THREE MILE ISLAND NUCLEAR GENERATING STATION, UNIT 1

Technical Specification
Change Request No. 4
Docket No. 50-289

Technical Specification Change Request No. 4

Changes are requested to impose different operating limits as derived from sections of the B&W Topical ECCS analysis and thereby ensure compliance with 10CFR50.46.

Figure 3.5-2A

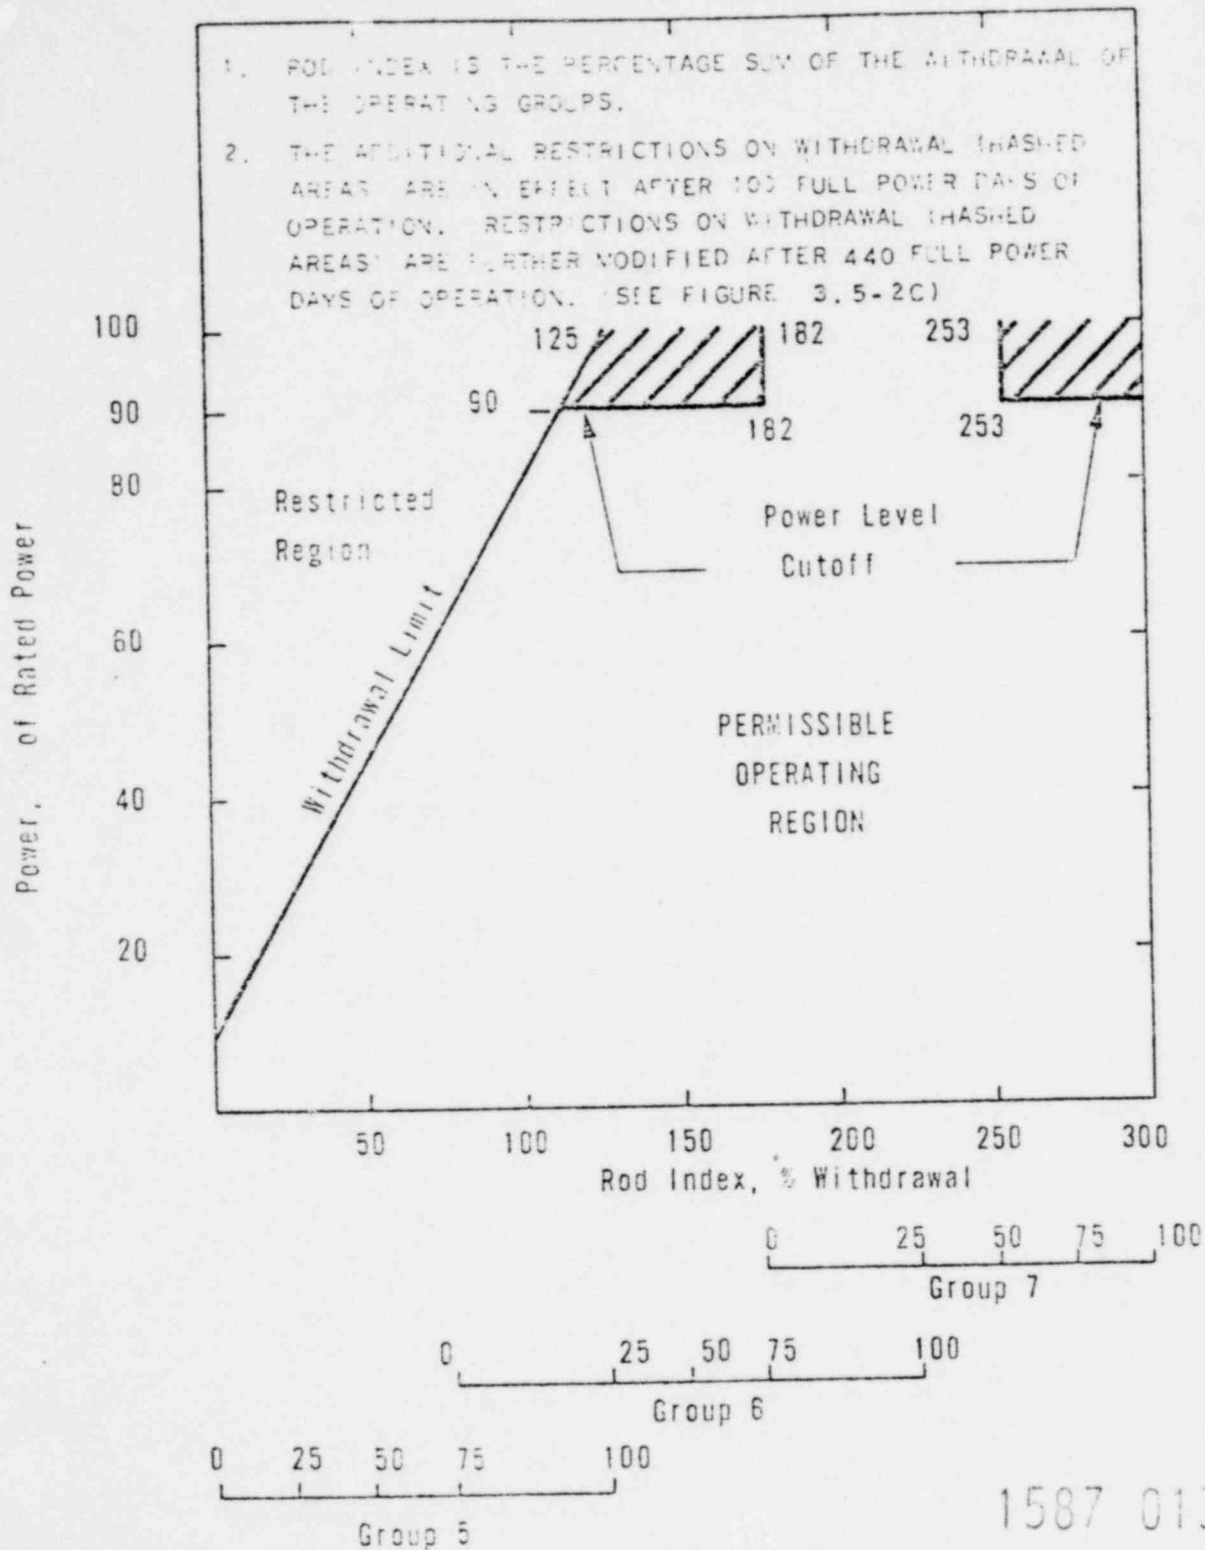
- a. Operating rod group overlap shall not exceed 25 percent, 15 percent, between two sequential groups except for physics tests.
- b. Except for physics tests or exercising control rods, the control rod insertion/withdrawal limits are specified on Figures 3.5-2A (for up to 100 full power days of operation), Figure 3.5-2B (for 100 to 440 full power days of operation), Figure 3.5-2C (for after 440 full power days of operation) for four pump operation, and Figure 3.5-2D for three or two pump operation. If the control rod position limits are exceeded, corrective measures shall be taken immediately to achieve an acceptable control rod position. Acceptable control rod positions shall be attained within four hours.

FIGURE 2D-2D

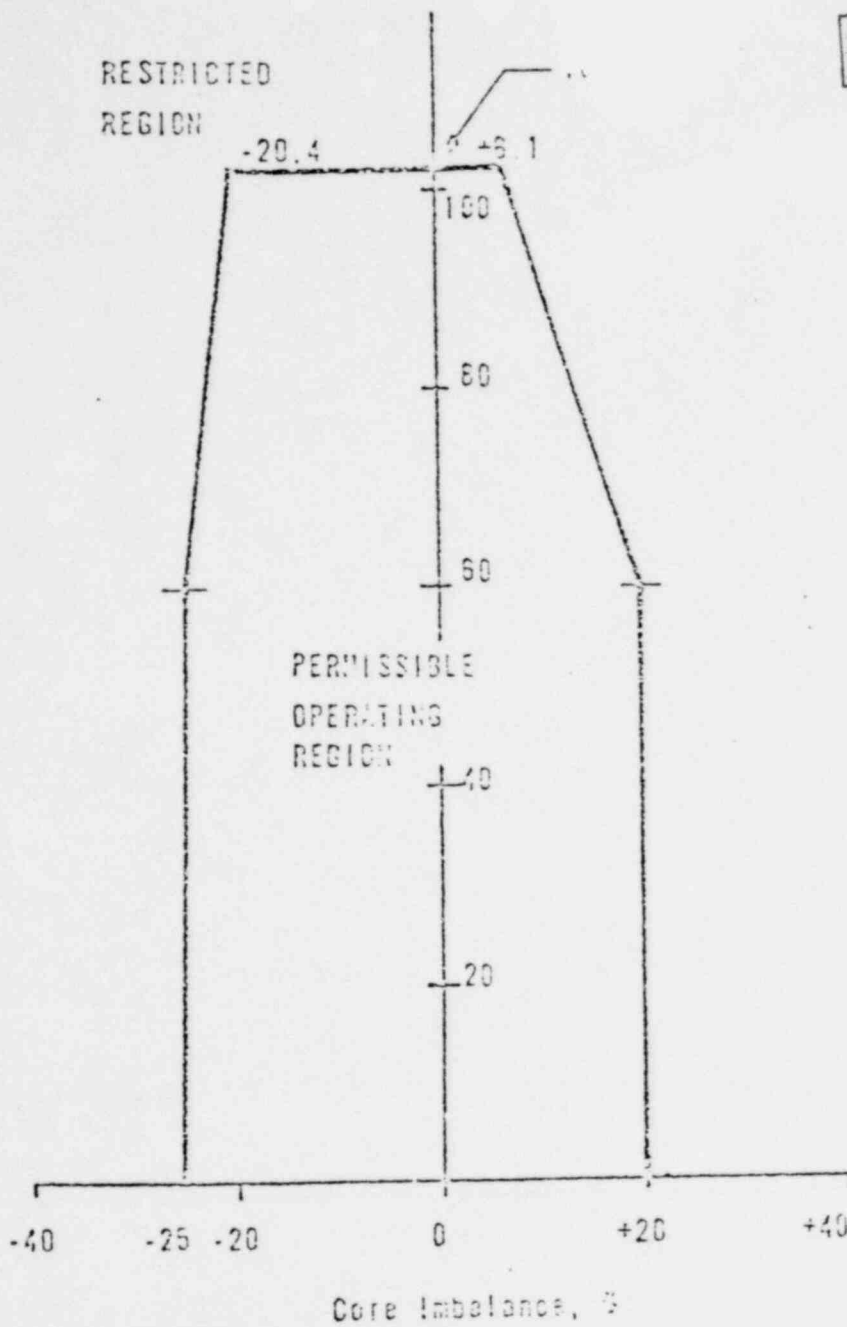
- 1. The protection system reactor power/imbalance envelope trip setpoints shall be reduced 2 percent in power for each 1 percent tilt.
 - 2. The control rod group withdrawal limits (Figures 3.5-2A, 3.5-2B, 3.5-2C, and 3.5-2D) shall be reduced 2 percent in power for each 1 percent tilt in excess of 4 percent.

FIGURE 3.5-2E

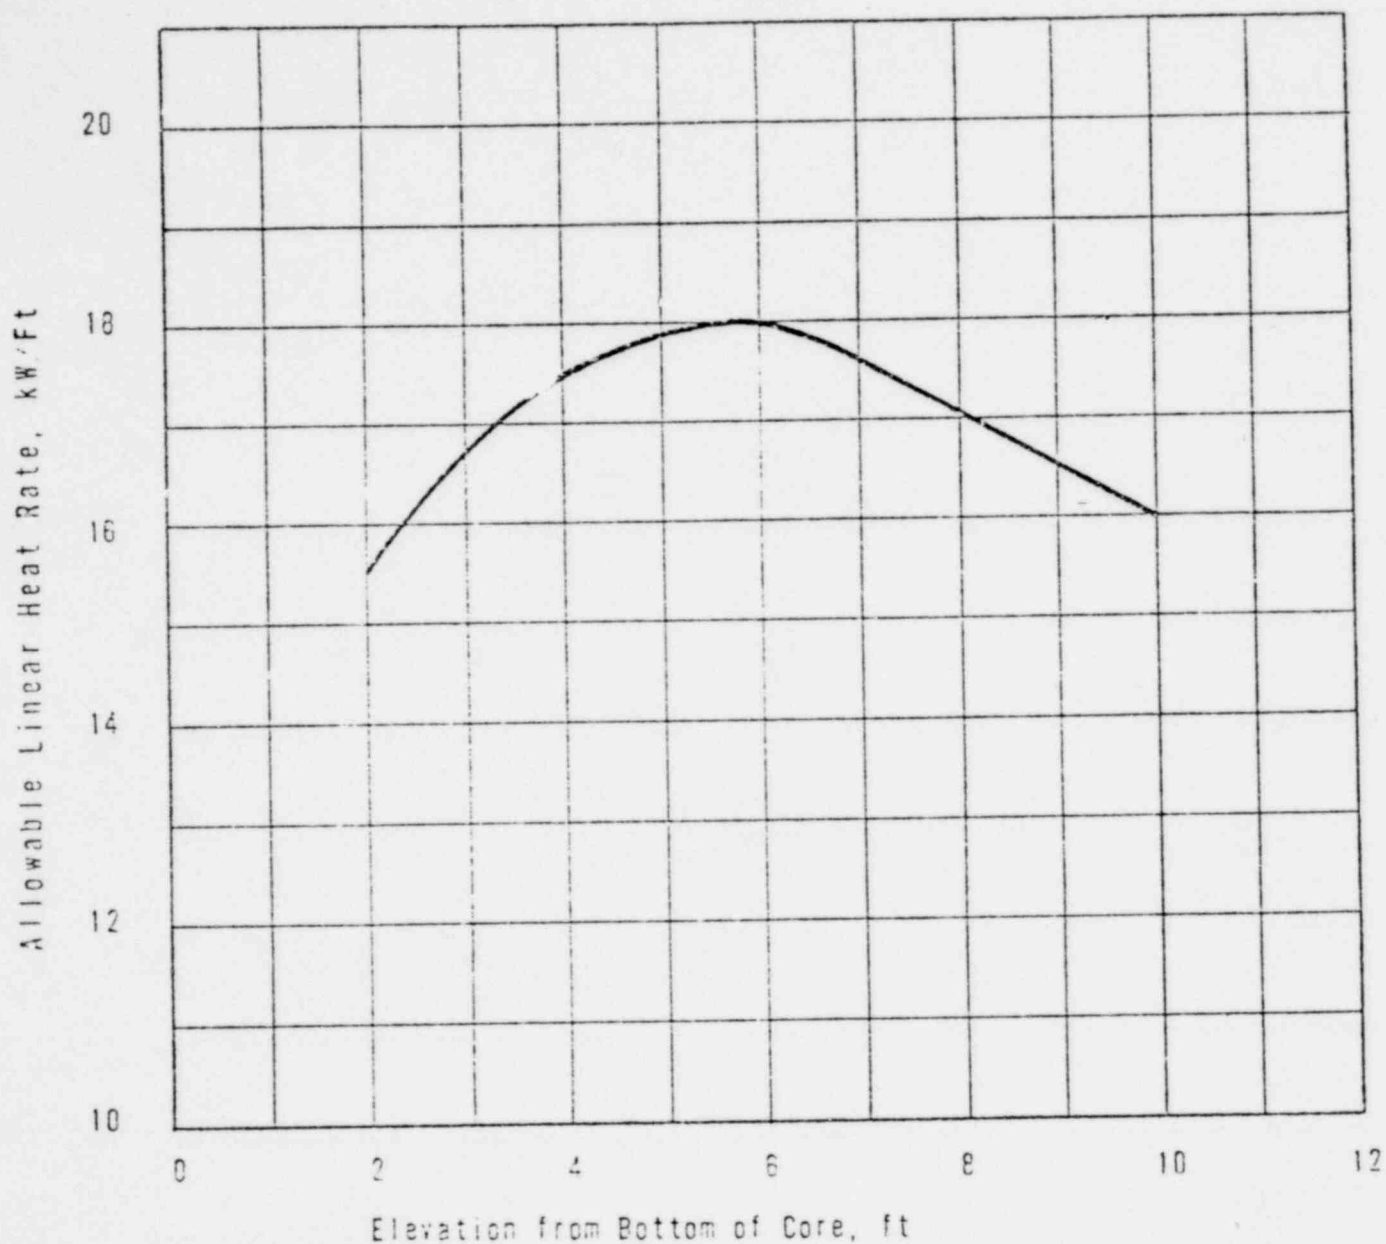
- 3. The operational imbalance limits (Figure 3.5-2E) shall be reduced 2 percent in power for each 1 percent tilt in excess of 4 percent.

- d. Core imbalance shall be monitored on a minimum frequency of once every two hours during power operation above 40 percent of rated power. Corrective measures (reduction of imbalance by APSR movement and/or reduction in reactor power) shall be taken to maintain operation within the envelope defined by Figure 3.5-2E. If the imbalance is not within the envelope defined by Figure 3.5-2E, corrective measures shall be taken to achieve an acceptable imbalance. If an acceptable imbalance is not achieved within four hours, reactor power shall be reduced until imbalance limits are met.

The power-imbalance envelope defined in Figure 3.5-2E, is based on LOCA analyses which have defined the maximum linear heat rate (see Figure 3.5-2F) such that the maximum clad temperature will not exceed the Final Acceptance Criteria. Operation outside of the power imbalance envelope alone does not constitute a situation that would cause the Final Acceptance Criteria to be exceeded should a LOCA occur. The power imbalance envelope represents the boundary of operation
